Access Compliance Report

Public Rights-of-Way

Intersection ID: 49004	Main Street: LITTLE_GEM_LN	Cross Street: STEELECROFT_PY	Location: SW
ADA ID: C437B6DAB3EC	Ramp Type: PerpDiag	Initial Pass/Fail: Fail	Overall Compliance: No
			Severity Score: 21.25

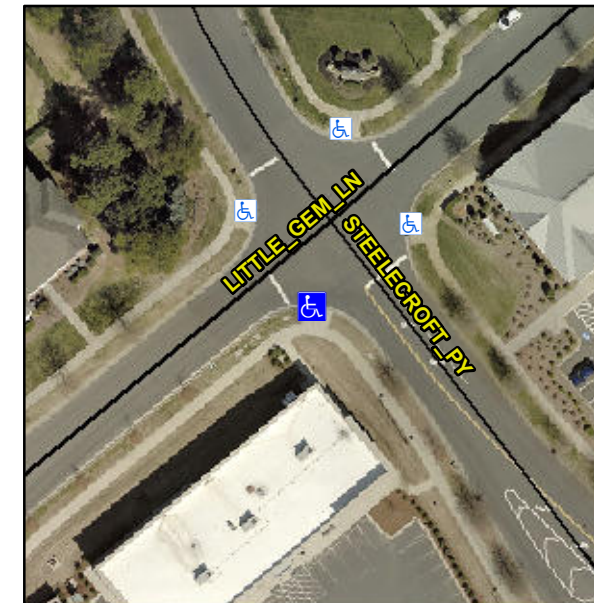
Not Found, R304.5.1, R304.2.2

Compliance	Description	Data	Compliance	Description	Data
N/A	Ramp Length (in)	98.0	No	Ramp Slope (%)	9.7
No	Ramp Width (in)	47.0	Yes	Ramp XSlope (%)	1.1
N/A	Flare Type LT	N/A	N/A	Flare Type RT	N/A
N/A	Flare Slope LT (%)	N/A	N/A	Flare Slope RT (%)	N/A
N/A	Flare Traversable LT?	N/A	N/A	Flare Traversable RT?	N/A
N/A	Landing Length (in)	N/A	N/A	DWS Provided?	N/A
N/A	Landing Width (in)	N/A	N/A	DWS Contrast?	N/A
N/A	Landing Slope (%)	N/A	N/A	DWS Length (in)	N/A
N/A	Landing X Slope (%)	N/A	N/A	DWS Full Width?	N/A
N/A	Landing Curb? (Y/N)	N/A	N/A	DWS Offset (in)	N/A
N/A	Shared Landing?	N/A			
N/A	Gutter Ponding?	N/A	N/A	Gutter Slope (%)	N/A
N/A	Gutter Lip Ht (in)	N/A	N/A	Gutter X Slope (%)	N/A
N/A	Painted X Walk1?	No	N/A	Painted X Walk2?	No
	X Walk 1 Direction	To NE		X Walk 2 Direction	To NW
N/A	X Walk 1 Width (in)	N/A	N/A	X Walk 2 Width (in)	N/A
	X Walk 1 Slope (%)	0.3		X Walk 2 Slope (%)	1.1
	X Walk 1 X Slope (%)	1.4		X Walk 2 X Slope (%)	1.9

Remove & Replace Curb Ramp With Two New Directional Ramps or Equivalent.
